SERVICE INFORMATION

Bulletin Nbr: 811-2101

Soft top cover latch jams due to deformed hinge

Saab 9-3 Convertible M98-M99 up to and incl. chassis no. X7063257.

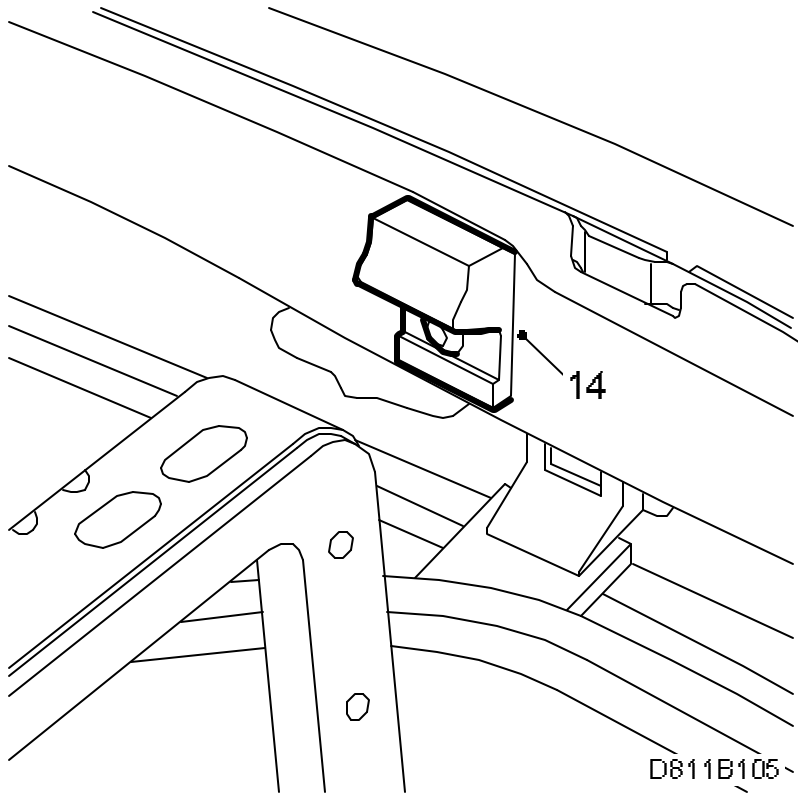
Fold down the hinges and open the boot lid.
10. Mark the position of the left hinge on the body and remove the left hinge.
11. Lift away the rod with the springs.
12. Mark the position of the right hinge on the body and remove the bolts securing the hinge.
13. Pull out the hinge from the joint.

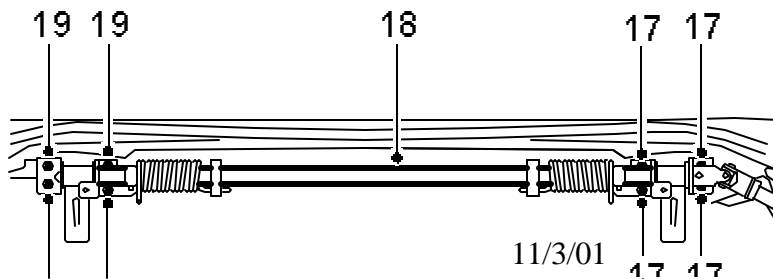
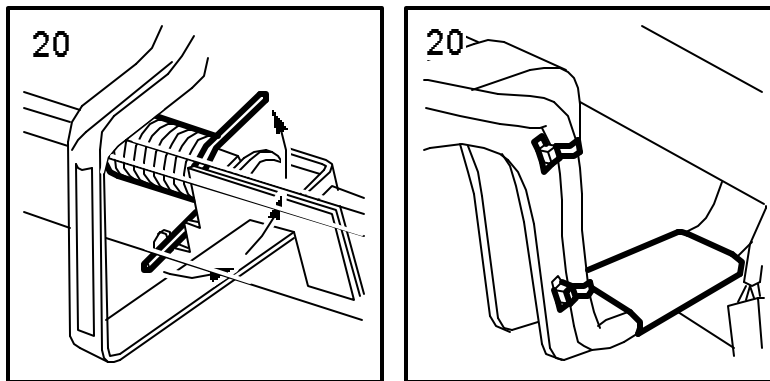
14. Drill out the blind rivets securing the dampers and remove them.

15. Fit the new dampers.

16. Transfer the washers and clip nut from the old hinges to the new ones.
